Project Name: Swinton Social

Project Location: 27-43 South Swinton Avenue and 104 SE 1st Avenue

Board: Historic Preservation Board

HISTORIC PRESERVATION BOARD CITY OF DELRAY BEACH STAFF REPORT

PROPOSED EAST ELEVATION (FACING INTERIOR OF SITE)

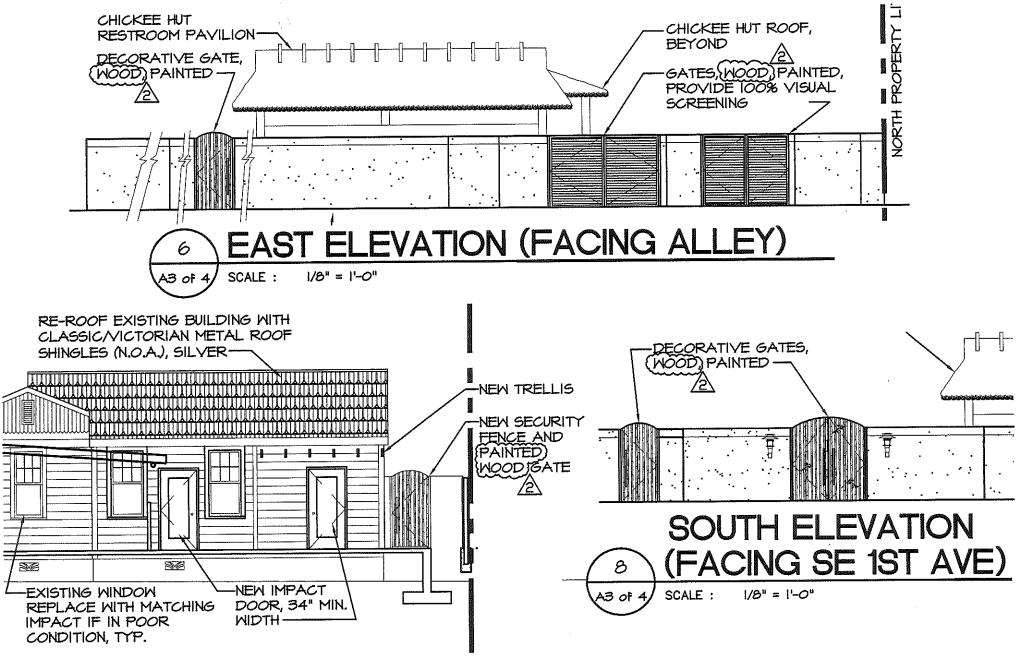
CANVAS AWNINGADDED ONTO SHEET A3 OF 4

Inspiration Photo for Guardrail Design

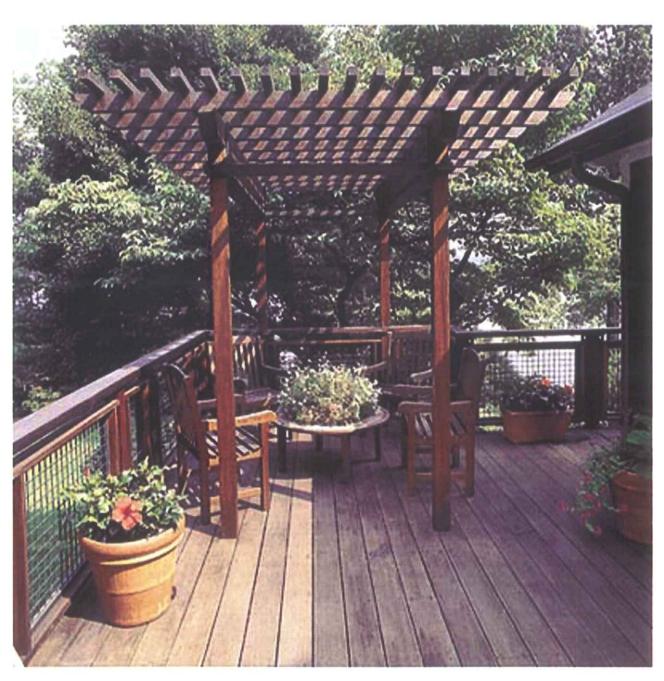
REVISED ON SHEET A3 OF 4

PERMEABLE PAVERS

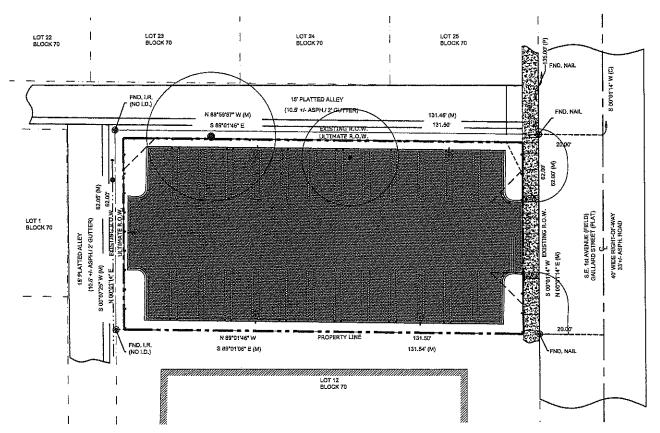
REVISED ON SHEET VALET LOT A1 OF 1
